**ADDENDUM NUMBER ONE (1)  
TO THE PLANS AND SPECIFICATIONS FOR:**

**NORTH ECHS  
AND  
COLLEGE & UNIVERSITY CAMPUS  
STUDENT RESTROOM RENOVATIONS**

**PSJA ISD  
Bid # 18-19-042  
Project No. 19.04**

GIGNAC & ASSOCIATES  
3700 N. 10<sup>th</sup> STREET, SUITE 205  
McALLEN, TEXAS 78501  
(956) 686-0100

**UNIVERSITY**  
**CAMPUS**  
**DEMO PLAN**

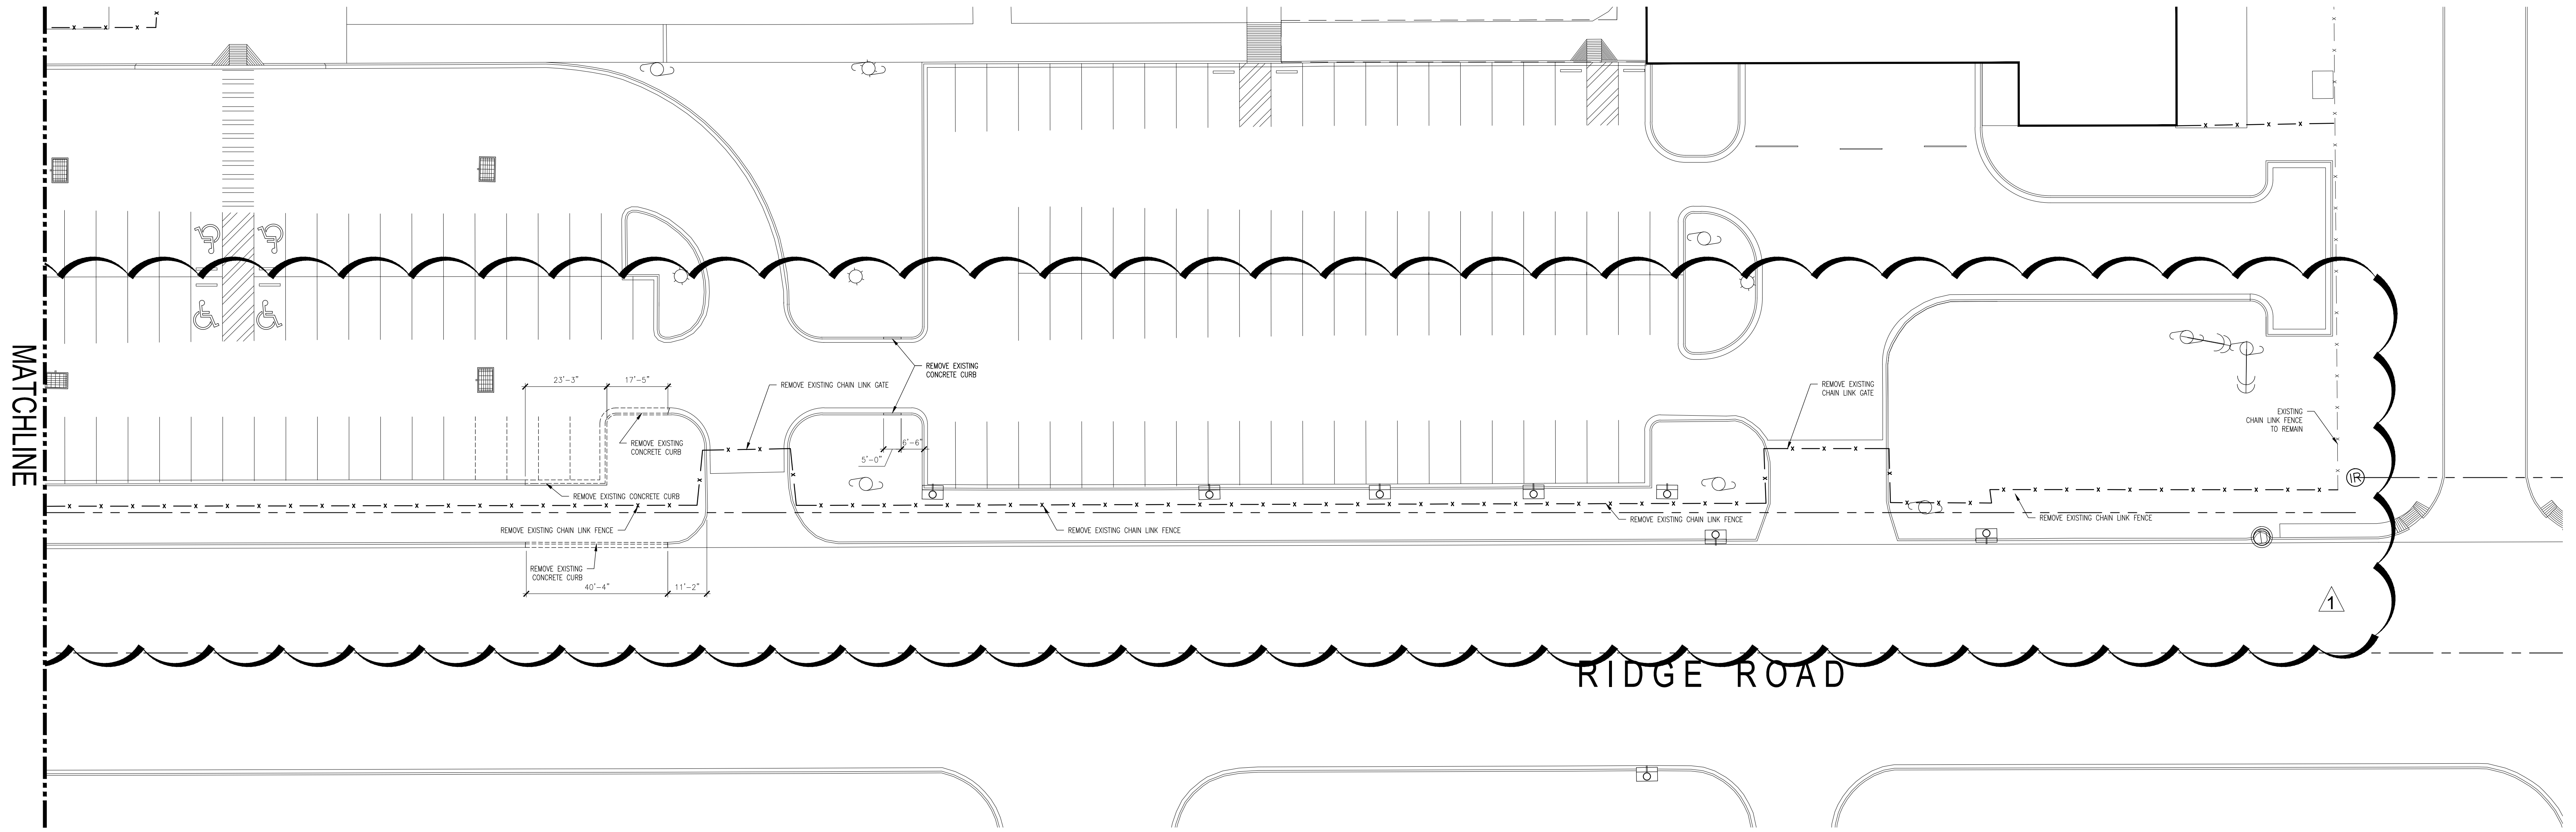
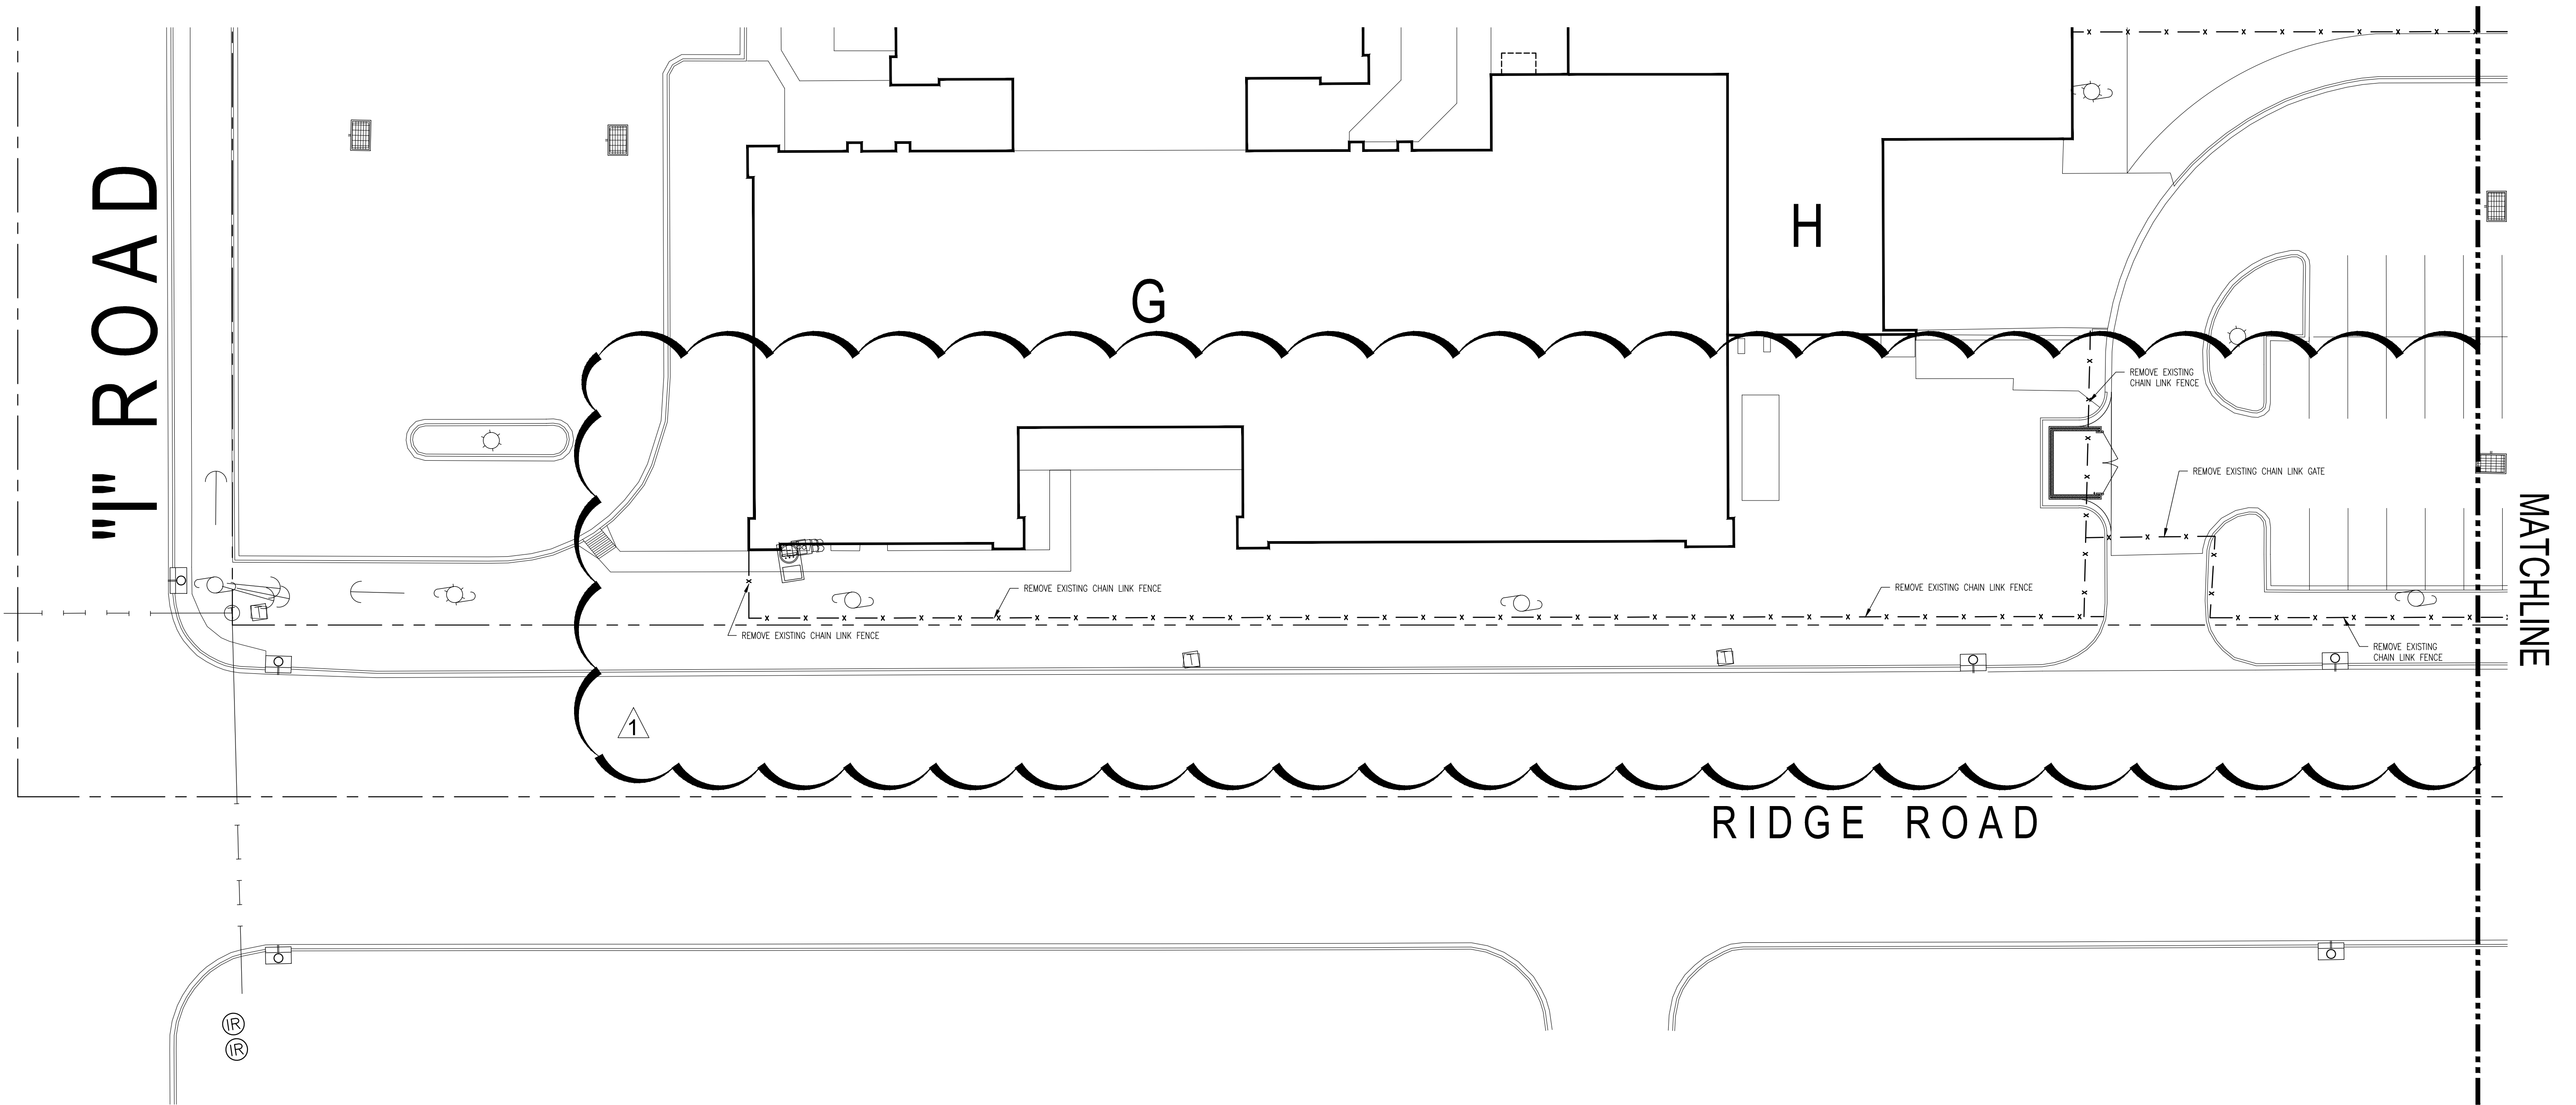
Sheets DS-200-U (Demolition Site Plan) and AS-200-U (Architectural Site Plan) included in this Addendum shall be included as part of the Contract Documents. Scope consists of ornamental fencing and concrete curb / flatwork modifications to existing site.

1 OVERALL SITEPLAN - PSJA NORTH ECHS  
1" = 40'-0"

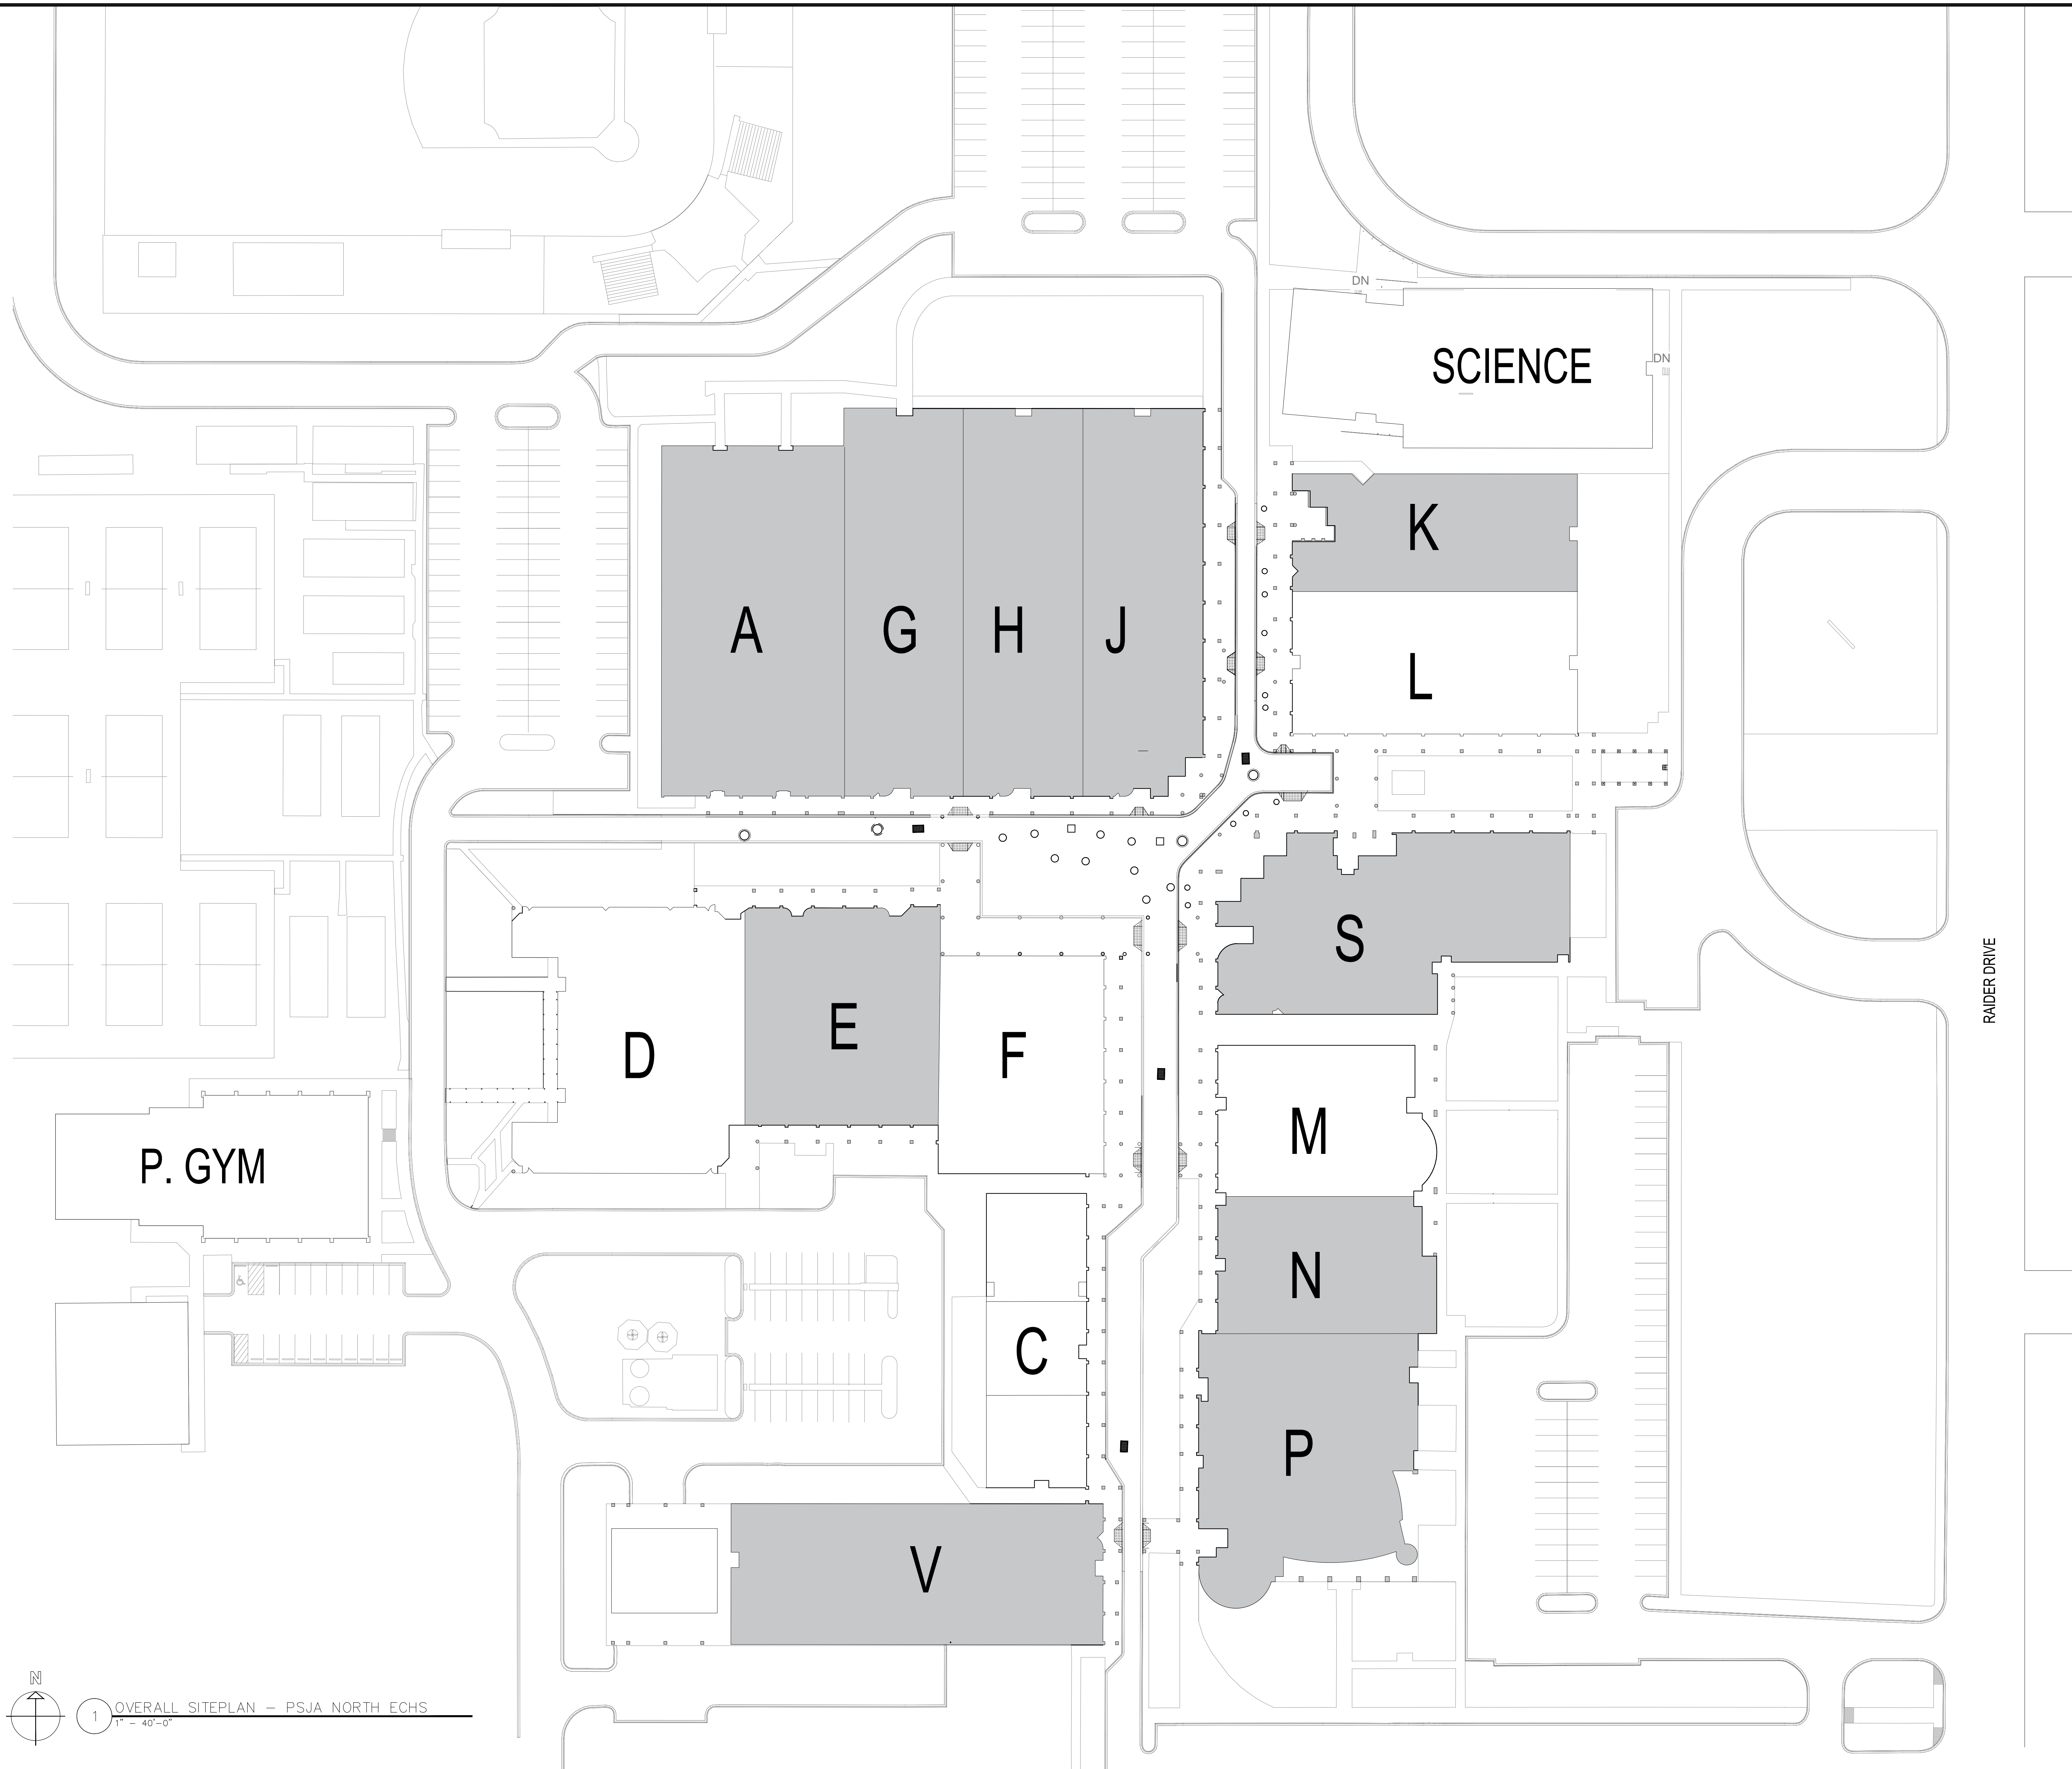
AS-100-N (Overall Site Plan) included in this Addendum shall be included as part of the Contract Documents. The following sheet gives a map of the campus and highlights which building contains a restroom pod that is being renovated.
